# Technical Service Bulletin

## 57 Customer autolock setting "Lock when driving" not available in MMI menu

57 13 93 2035173/1 September 5, 2013.

Model(s)	Year	VIN Range	Vehicle-Specific Equipment
Q5	2013-2015	All	MMI Navigation plus

Figure 1. Autolock configuration prior to model year 2013.

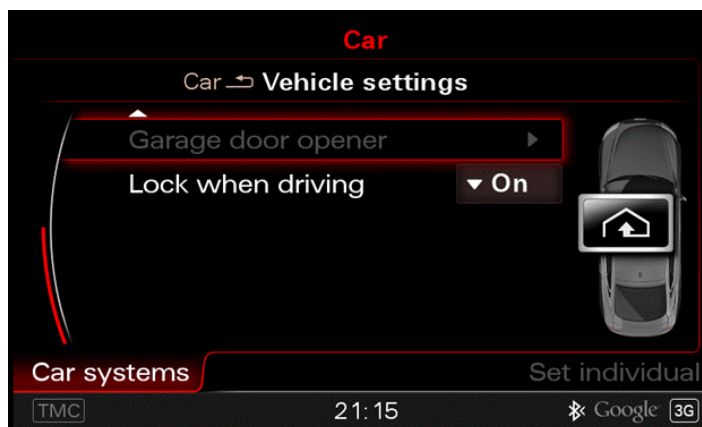
The "Lock when driving" (Autolock) configuration setting has been discontinued starting in some model year 2013 vehicles, and it is no longer available in the *Car >> Vehicle Settings* category in the MMI (Figure 1).

The vehicle can still be unlocked while it is being driven, at any time, with the central locking switch in the door.

Explain the technical background of the locking configuration setting to the customer.

If a customer has concerns about this feature, please make a Technical Assistance Center (TAC) contact to further help the customer.
